DETROIT™

No.: 14 OEM-02A
21FEB14
Revised 14MAR14

SUBJECT: MY2016 Changes to DD Series Engines, Electronics and Aftertreatment Systems

Figure 3: Soot Sensor shown on 1-Box ATS

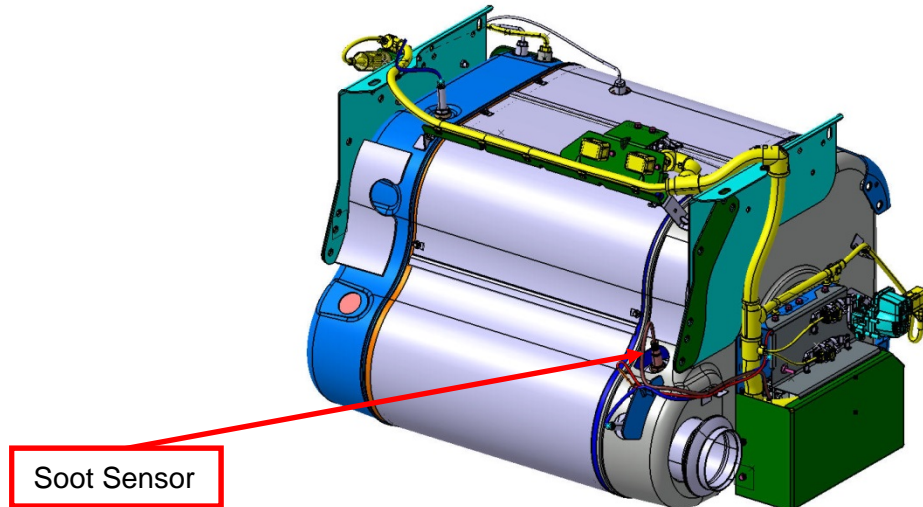
The implementation of a Soot Sensor is being added to all 1-Box ATS configurations for MY2016. Vehicle installations utilizing a 2-box ATS are required to have the soot sensor in place for MY2015.

Figure 4: ATS Mounted ACM shown on 1-Box ATS

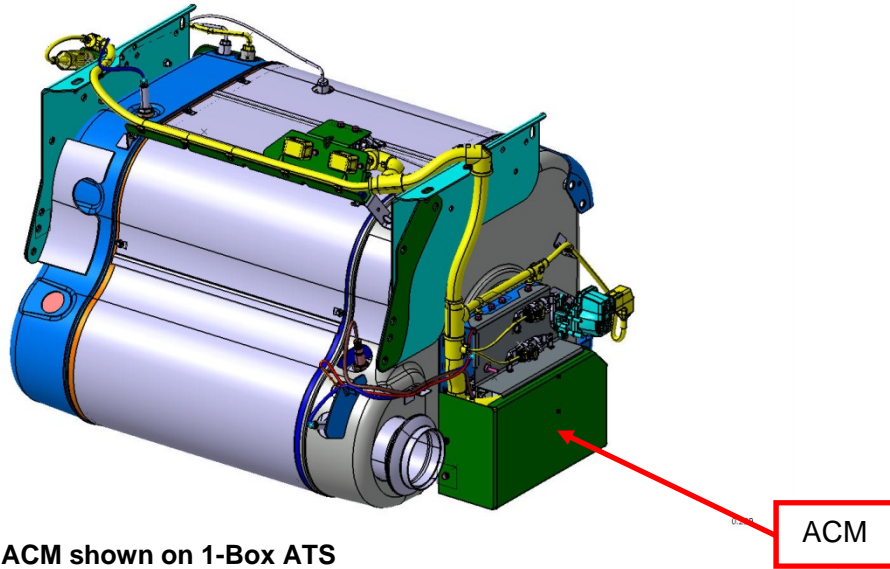
The ACM will be mounted directly on the 1-Box ATS beginning in MY2016. As a result, the wiring harness has also been simplified. OEMs will now only be required to connect the engine harness to two 18-pin connectors, shown below on top of the ATS, in place of the current 47-way connector. Contact your DETROIT Application Engineer for the pin-outs of the two 18-way connectors.

Figure 5: SSI DEF Header with Integrated DQS

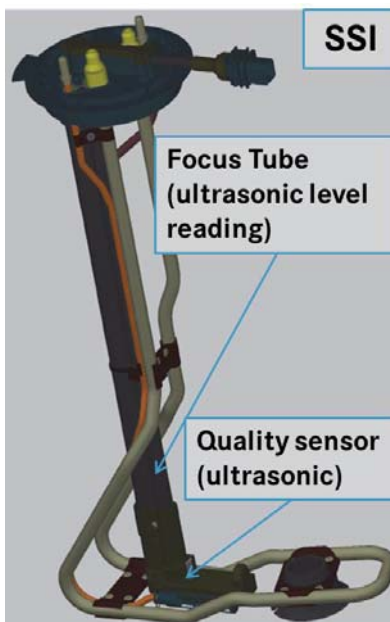
A DEF Quality Sensor (DQS) is required for MY2016. The preferred method would be to utilize the SSI header with the integrated DQS as part of the header assembly. The wiring harness for the header assembly will also need to be modified to communicate this sensor back to the ACM.
